Illustrated Parts List - IPL Update

H440 II

1. Oil hose

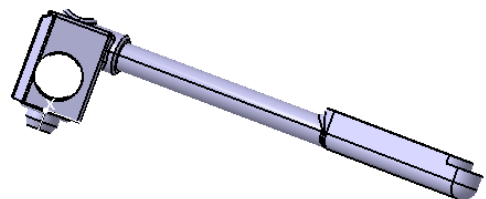
1. Updated Oil Hose 544 08 42-02 added. Sealing knob removed to simplify assembly.
